**LEXINGTON-FAYETTE URBAN COUNTY GOVERNMENT
CONTRACT CHANGE ORDER**

Date: **January 12, 2017**
Project: General Services Building Roof Replacement
Location: 1555 Old Frankfort Pike

CHANGE ORDER: 1

PROPOSAL REQUEST NUMBER: 002

1 ROOF PLAN
SCALE: 1/8" = 1'-0"

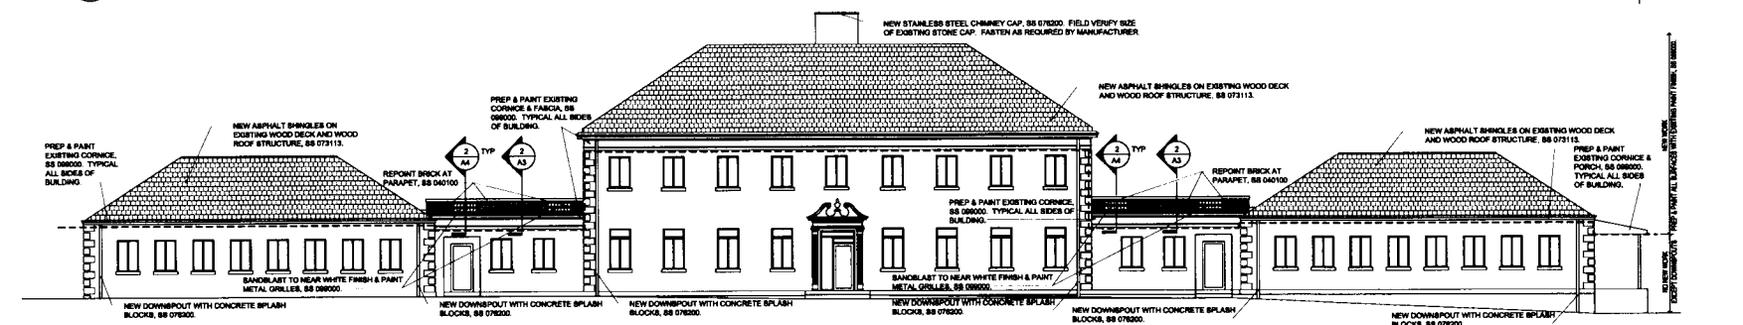
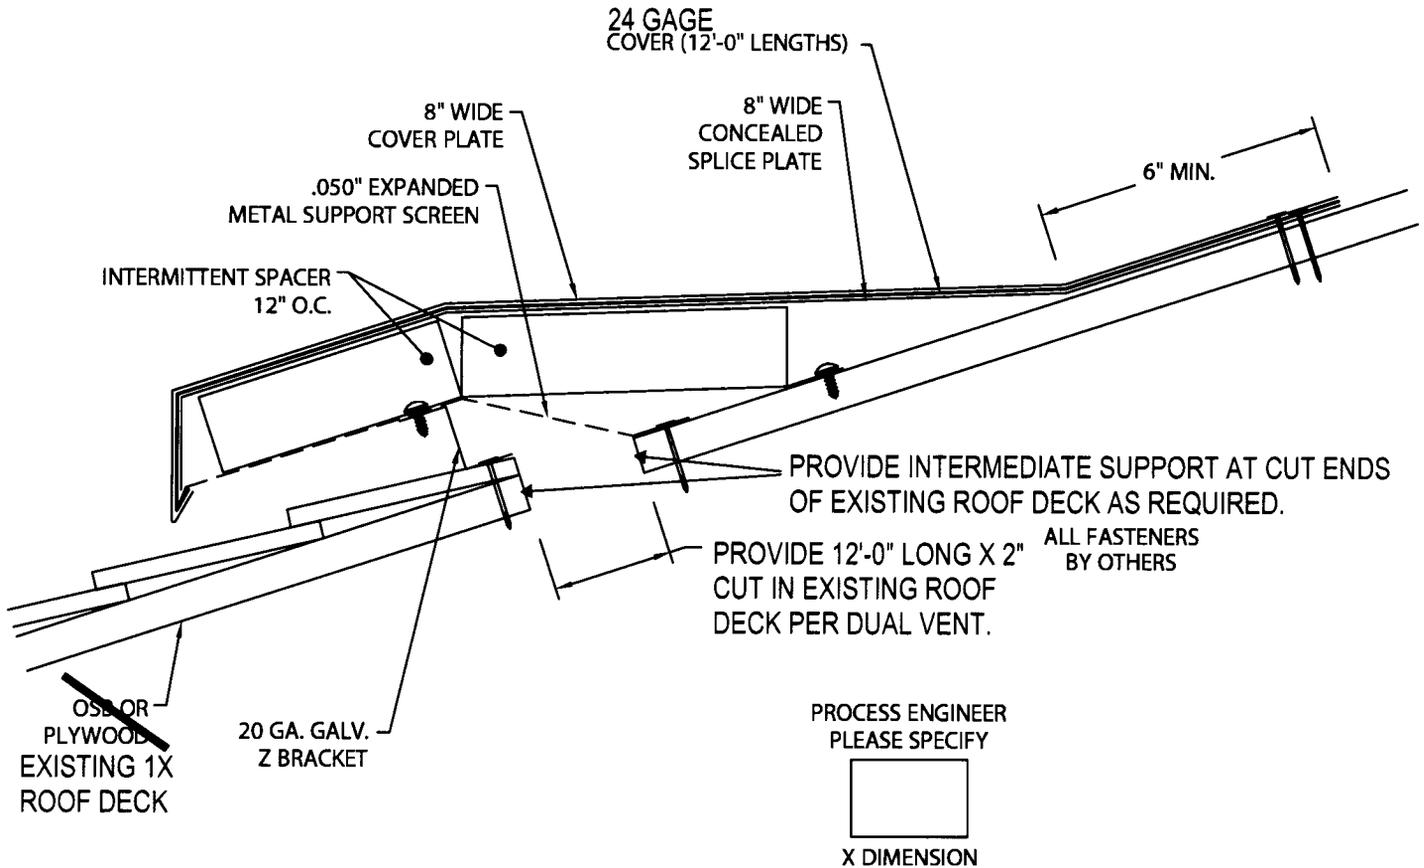
Provide a breakdown of material cost and labor to install ten 12'-0" lengths (120'-0" feet total) of the 24 gage Metal Era Dual Vents and eighteen end caps. The vents shall be located in conformance with the attached plan and installation details. The 2" cut in the roof deck shall occur 3'-6" from the roof eave. Provide intermediate wood support at the cut ends of the roof deck as required.

Provide labor credit for eliminating the cuts to the soffit boards at Areas A, B & C.

Provide labor credit for eliminating the modification of the decorative 1x10 trim board in Area C.

PROPOSAL REQUEST #2
 SUPPLEMENTAL DRAWING #1
 DECEMBER 28, 2016

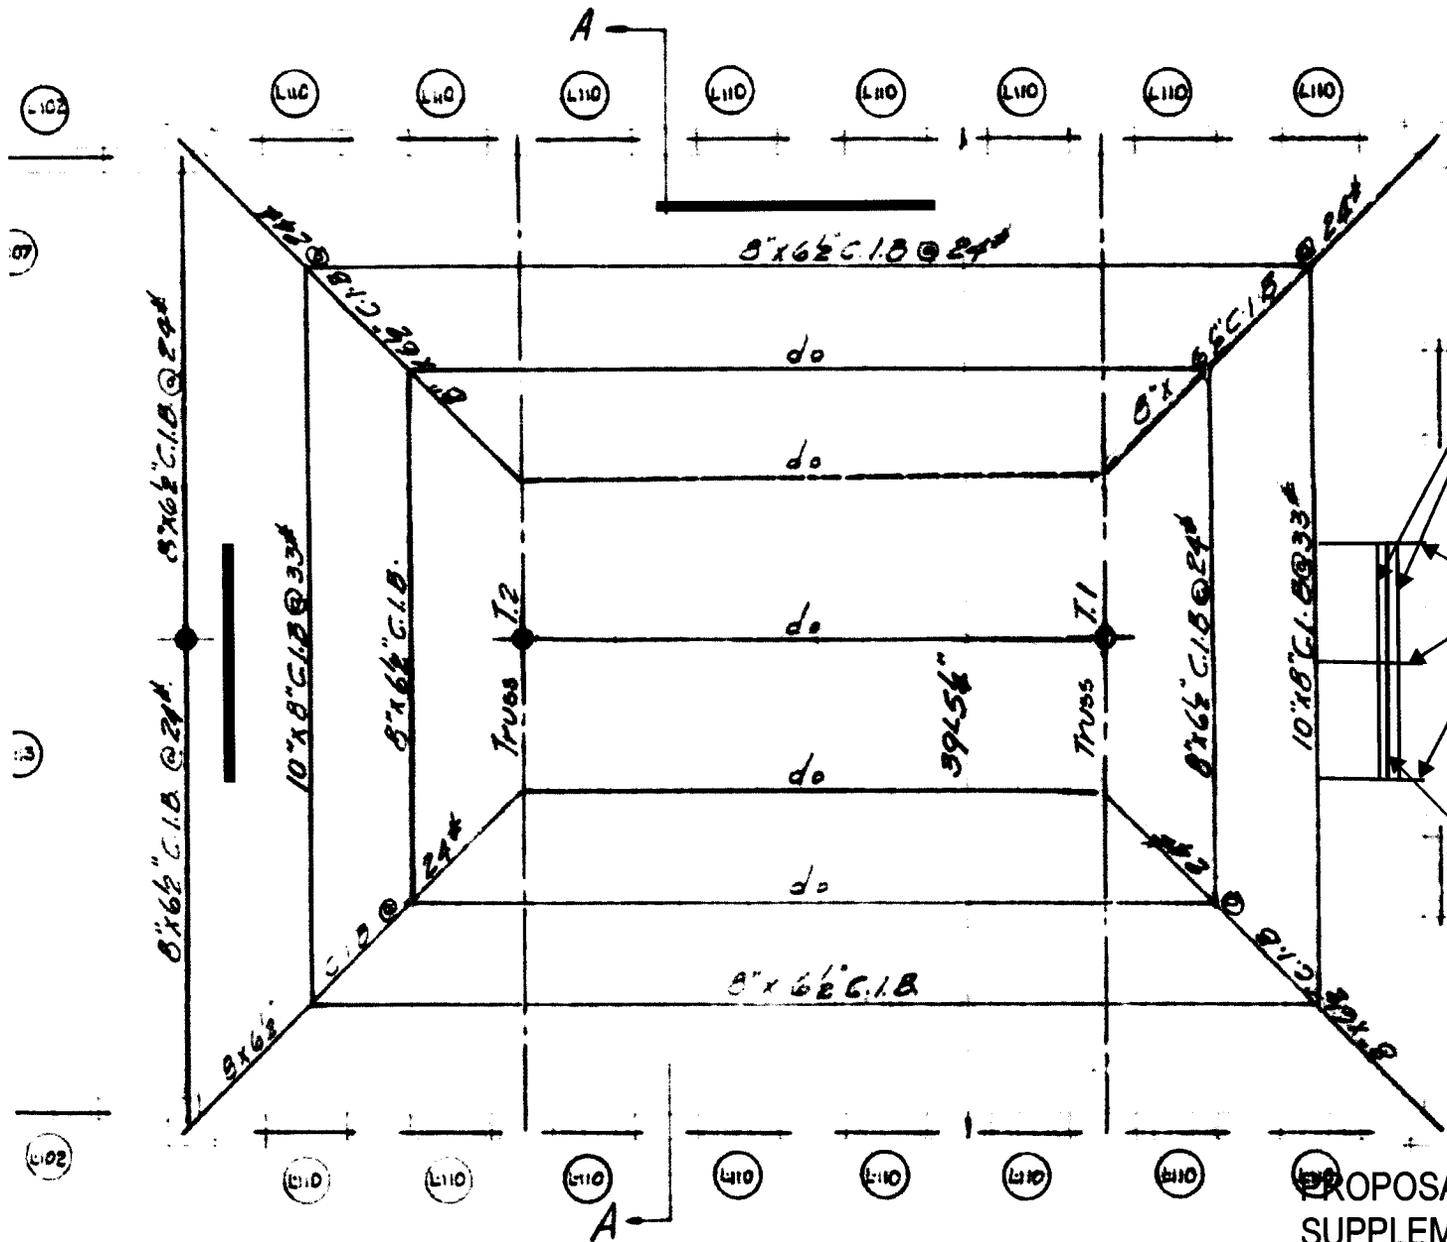
(2) 6 IN., 18 GAGE METAL STUD RUNNING BOTH SIDES FULL LENGTH OF 2" X 12' CUT IN ROOF DECK.

(3) DOUBLE 6 IN. 18 GAGE METAL STUDS RUNNING FROM EXISTING STEEL W SECTION TO MASONRY WALL.

2" X 12' CUT IN ROOF DECK
